Island Point Road Residential Subdivision

*Modification Assessment
(DA 277-11-2004 MOD 3)*

March 2019

Figure 4: Proposed subdivision layout

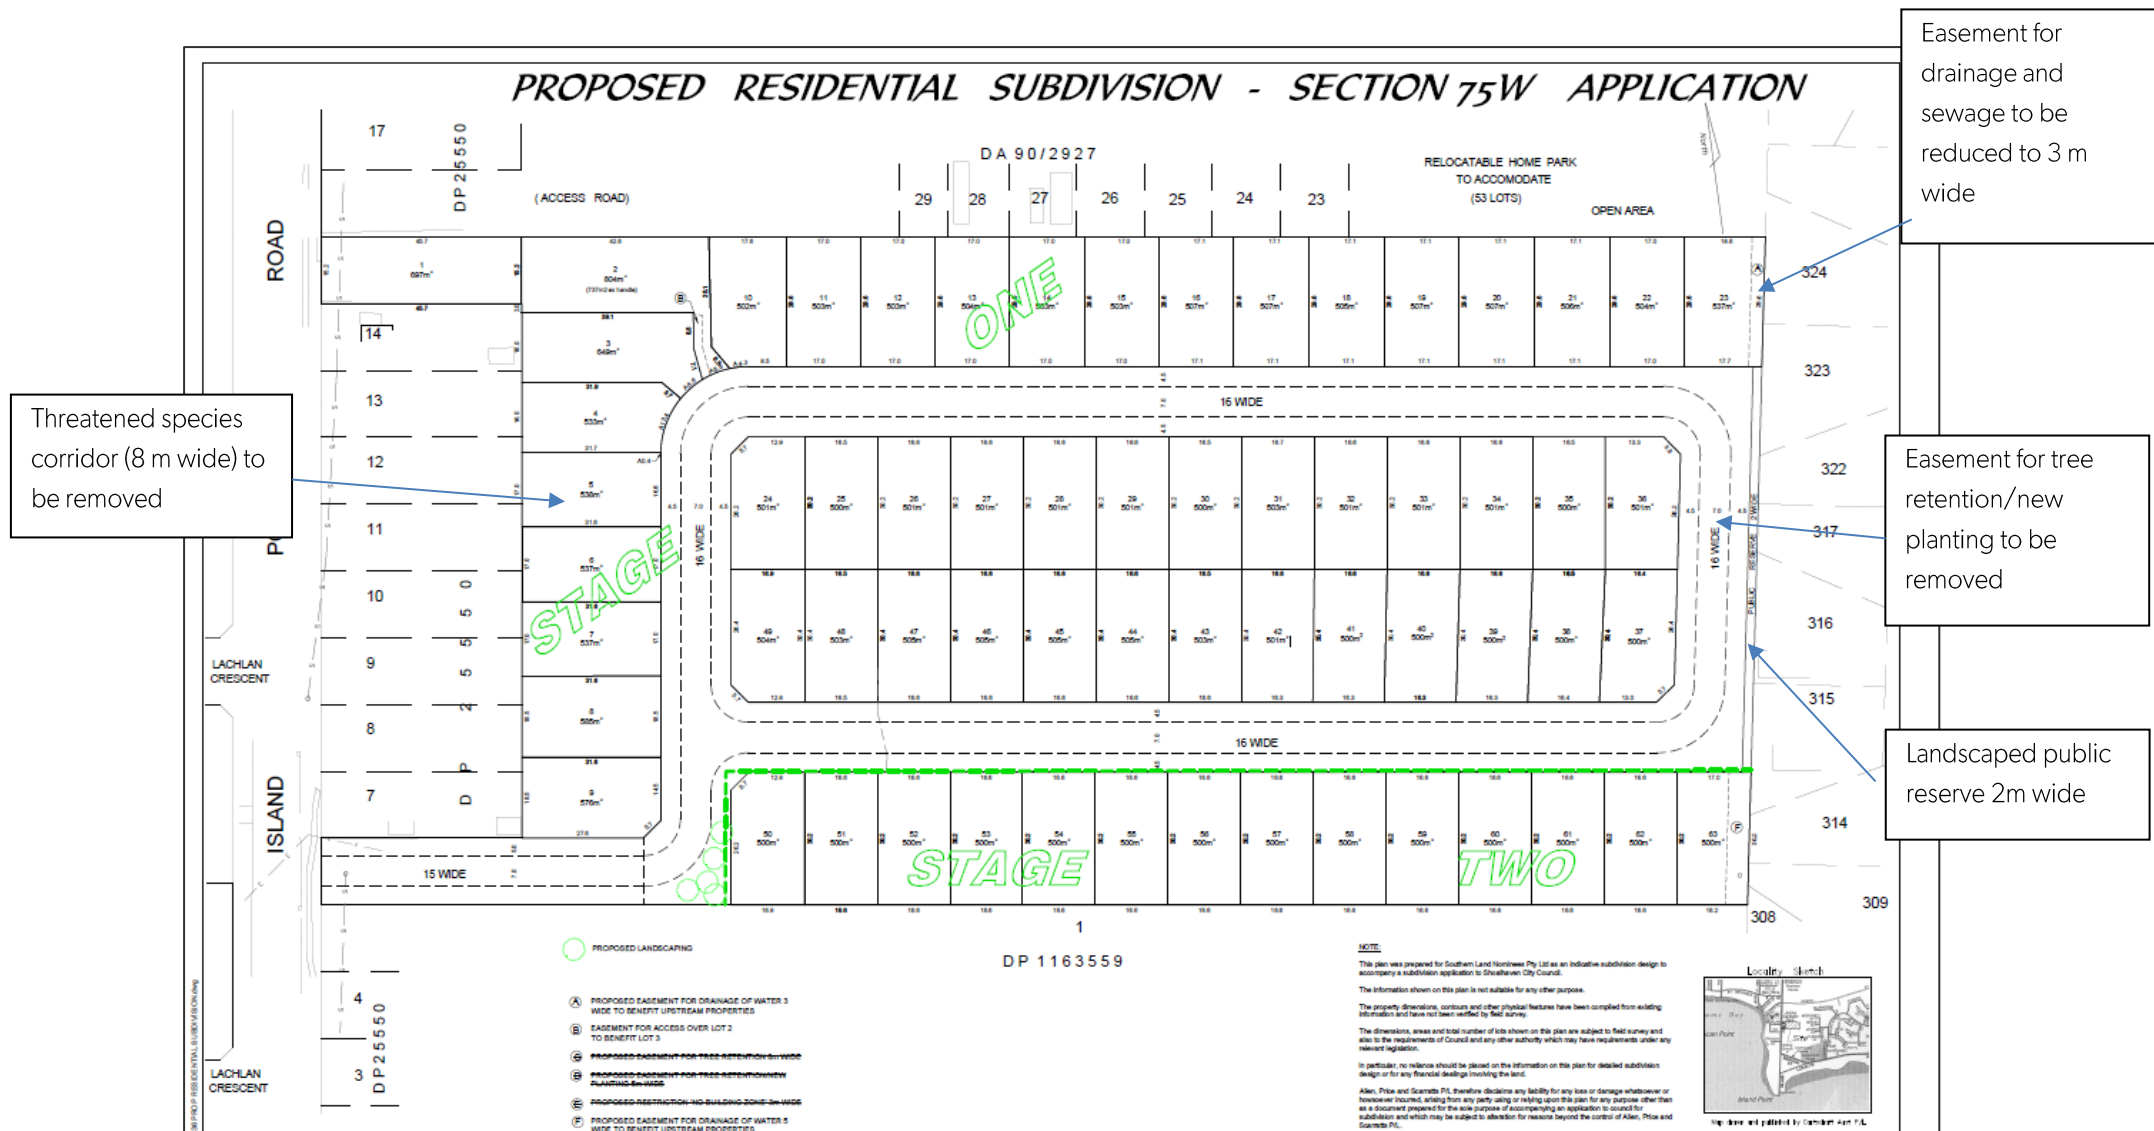
Issue	Consideration	Recommendation
Subdivision Layout	<ul style="list-style-type: none">The proposal seeks to amend the approved subdivision and road layout to accommodate an additional 19 lots (refer to Figure 4).The Department considers the revised lot layout provides a logical subdivision pattern which better integrates with surrounding development.In particular, the Department notes the amended design would result in a better outcome, as it would remove the road directly facing the southern boundary of the site, and the landform has been amended to more closely align with the natural topography of the site.The revised lots are mainly north to south oriented, maximising solar access for dwellings and private open space. The proposed layout would also reduce the number of irregular shaped and battle-axe lots.Further, the Department notes the proposed subdivision layout is consistent with the majority of Council's controls. All lots meet the minimum lot size of 500 m² in accordance with the Shoalhaven LEP 2014.The Department notes Council's DCP requires a minimum lot width of 16 m and depth of 30 m for rectangular lots and a mean width of 18 m for irregular shaped lots. The majority of lots meet the requirement, with some minor variations, which would not affect the amenity of future dwellings on the lots.Council raised concern about the width of the frontage for Lots 2 and 3 as it may impact on serviceability. In response, the Proponent updated the subdivision design to increase the lot frontage by 1.8 m and 3.3 m respectively.Overall, the Department considers the proposed subdivision layout, is acceptable, as it forms a logical subdivision pattern providing high levels of residential amenity, reduces the length of road facing the adjoining boundary of the site and it complies with the majority of Council's subdivision controls.	No additional conditions or amendments necessary.

Issue	Consideration	Recommendation
<i>Amenity impacts - eastern boundary</i>	<ul style="list-style-type: none"> The proposed modification seeks to amend the approved road layout as shown in Figure 4. The revised proposal would remove the road directly adjoining the southern boundary of the site. It has now been replaced with a loop road which would now directly adjoin the eastern boundary of the site (as shown in Figure 4). Council raised concern about potential amenity impacts of the proposed road along the eastern boundary on five adjoining lots. To minimise potential impacts on these properties, Council recommended that an easement for a strip of land directly adjacent to the boundary be provided as either a road reserve or a public reserve (under the care of Council). This would minimise amenity impacts and prevent unauthorised access to existing properties via the rear boundary. The Department agrees with Council that this would result in a better amenity outcome for these properties, and recommends a new condition requiring the strip of land along the eastern boundary of the site to be created as a landscaped easement. Overall, the Department considers the revised road layout is acceptable as it would reduce the length of road directly adjoining the side boundary of the site. Subject to the recommended condition requiring a landscaped buffer, the Department is satisfied amenity impacts to the adjoining properties to the east will be appropriately mitigated. 	The Department has recommended a new Condition C18 requiring a 2 m wide landscaped strip along the eastern boundary to be dedicated to Council as public reserve.
